RE: **Lot 26 Block 5, S.A.D. 227**
Unser Cliffs Subdivision
8016 Victoria Dr. NW
Grading and Drainage Plan
Engineers Stamp Date; 12-4-18 (E10D055)
Pad Certification Date; No Date

Based upon the information provided in your submittal received 6/14/19, this plan cannot be approved for Pad Certification until the following comments are addressed.

MARTINEZ, ADRIAN (BUILDER: MICHAEL SANCHEZ) - G & D PLAN

PAD CERTIFICATE

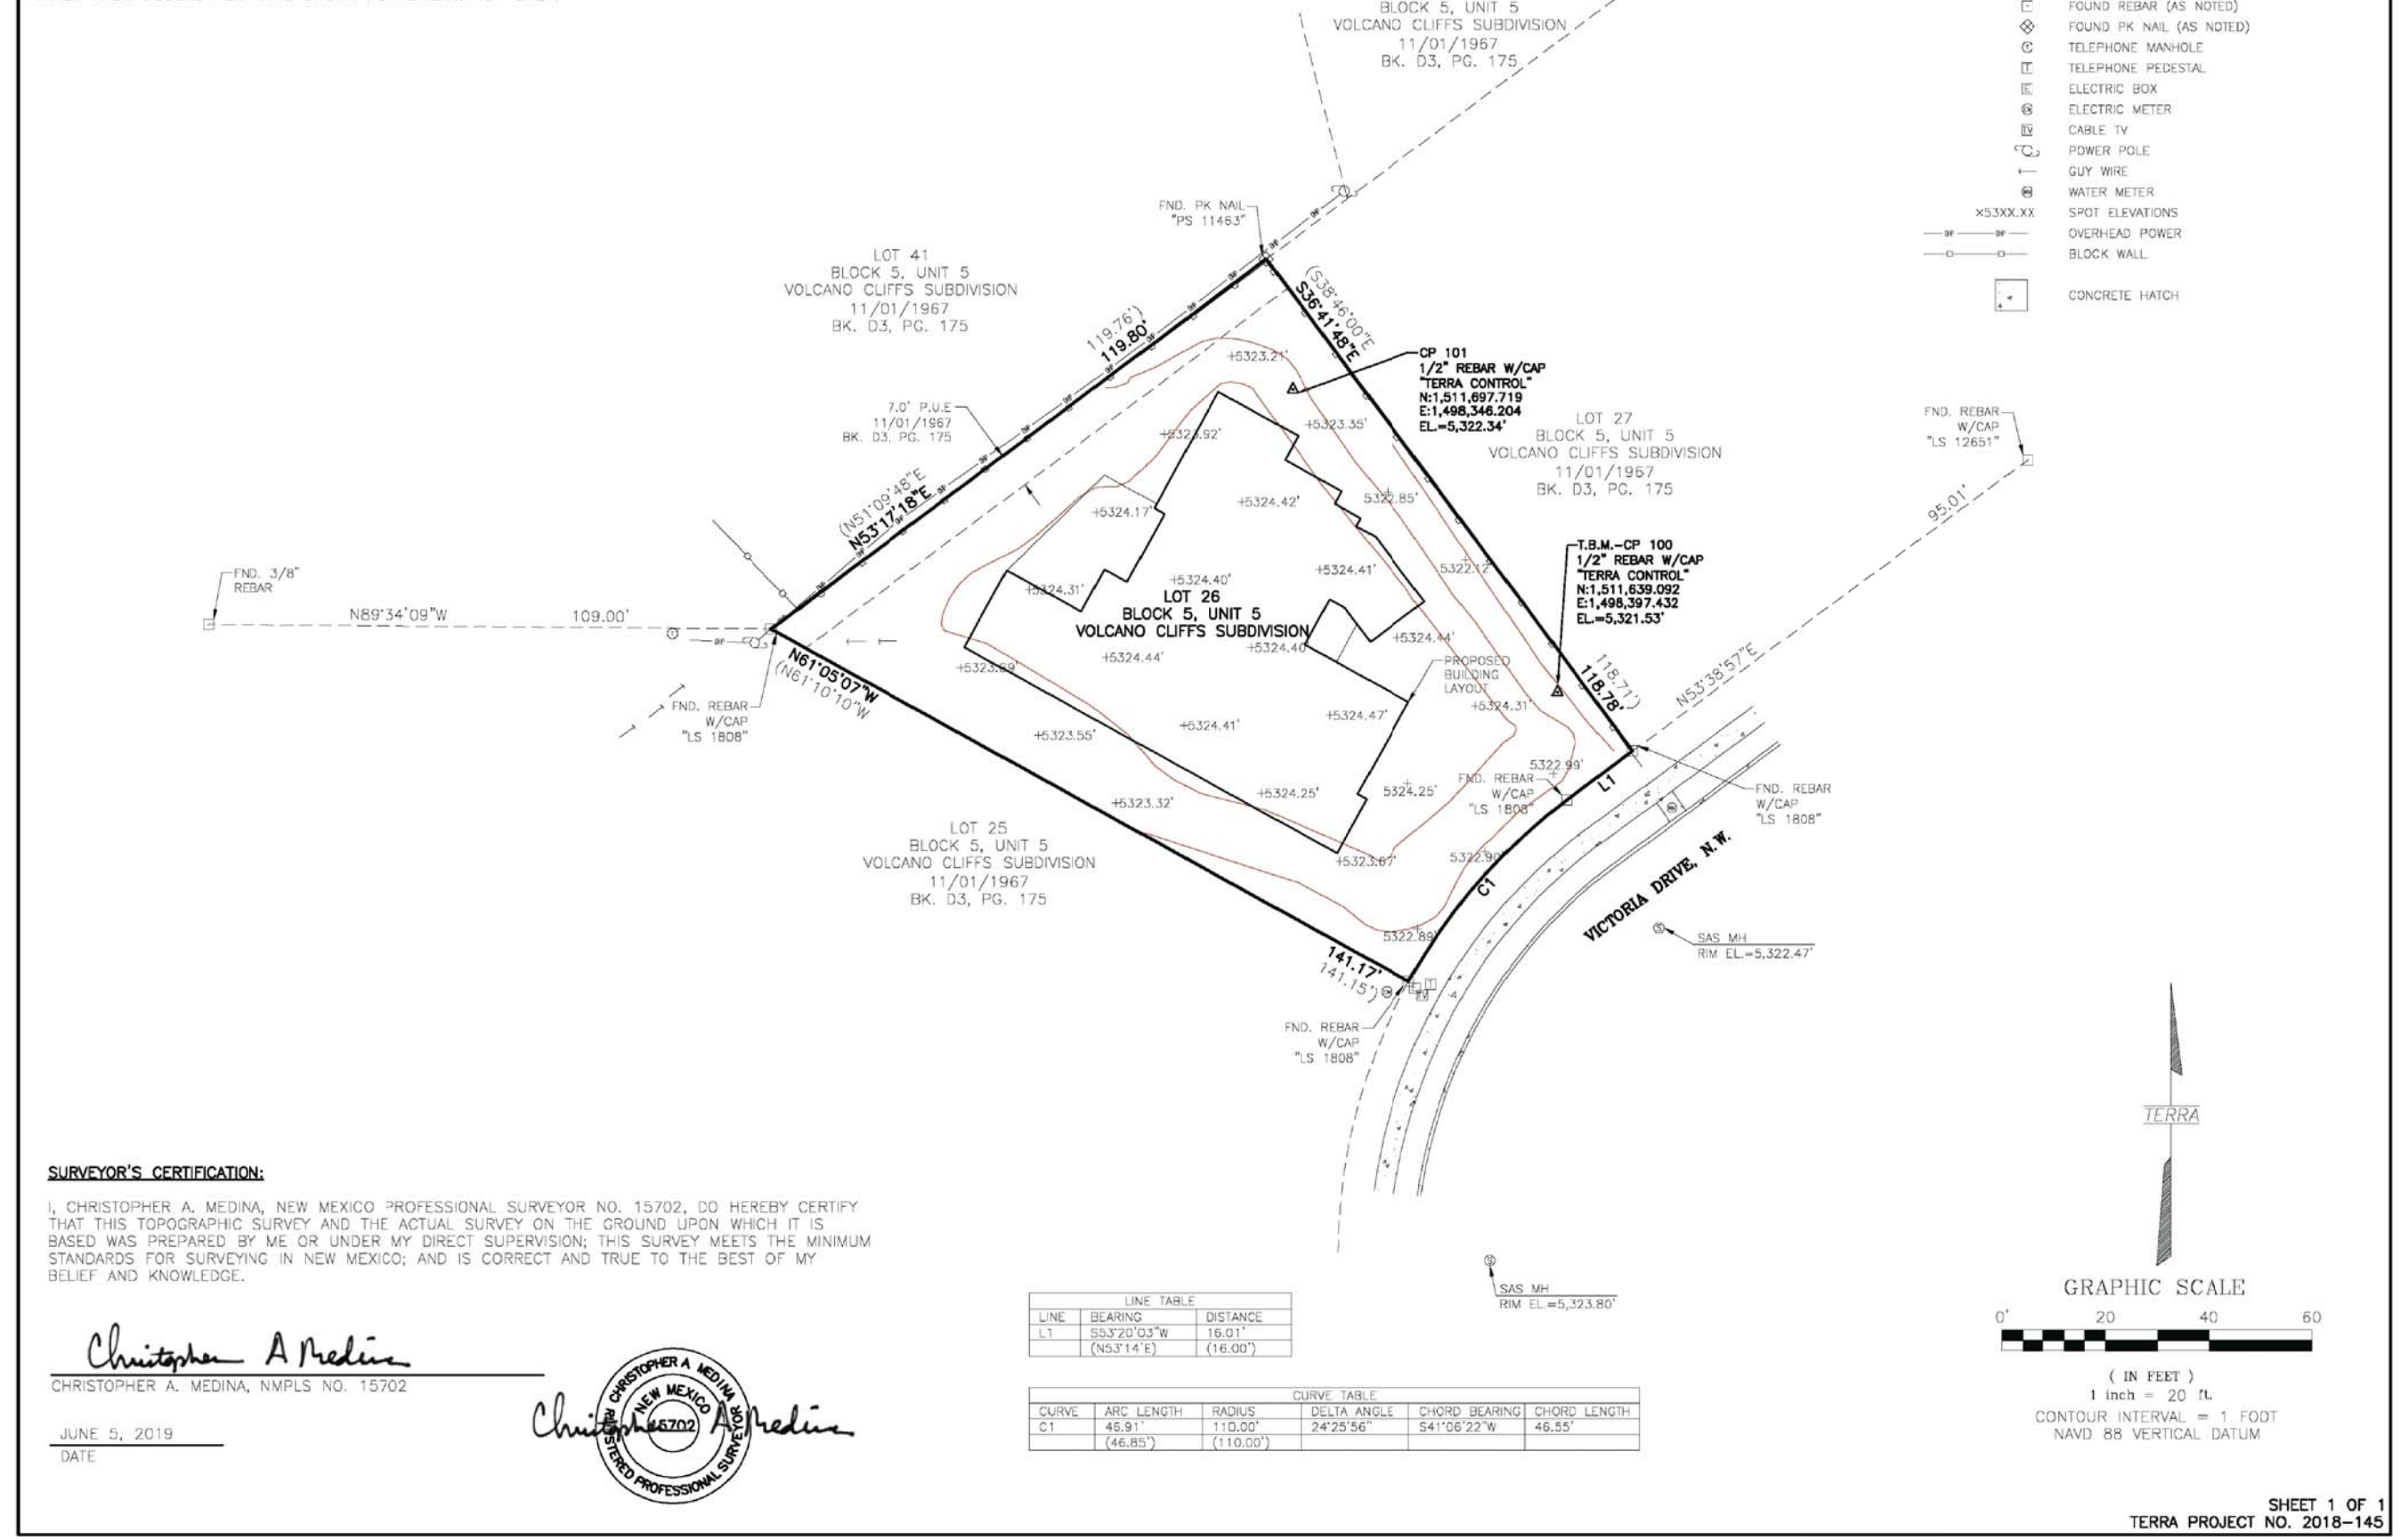
- A date must be provided along with signature in the pad cert box.
- Remove all dirt and debris from the street and sidewalk.
- A pad is not visible, trenches have been dug in the pad for plumbing and footings, once the pad is visible resubmit for pad certification.
